REMARKS

This is responsive to the Office Action mailed April 23, 2004. The application includes claims 1–27 and 29. Claims 21–28 are canceled.

Annotated Sheet Showing Changes

FIG. 2

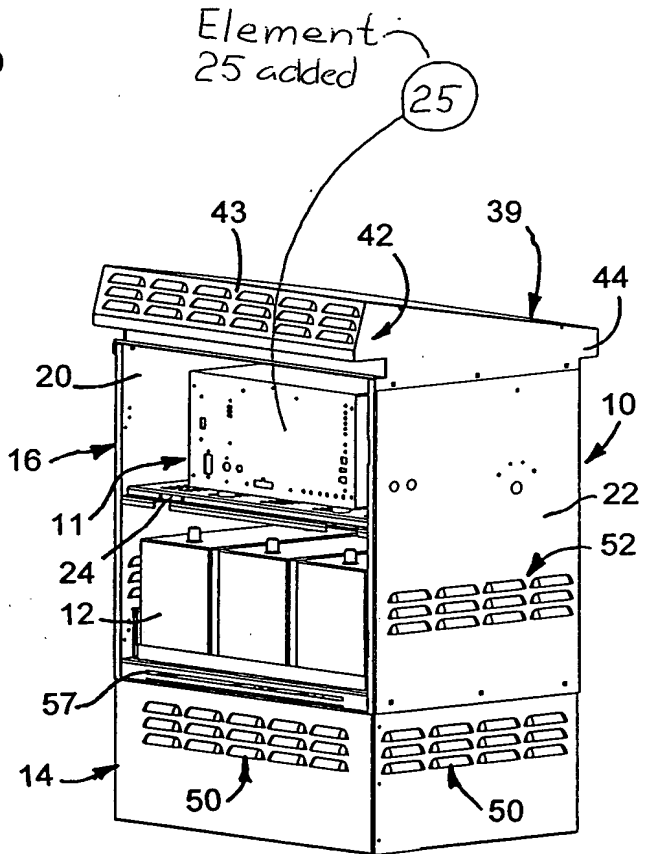
The drawings have been corrected by the adding of reference numeral 25 in Fig. 2. Reference number 25 is the UPS convertor and control unit, which are identified at specification page 6, lines 11 and 12.
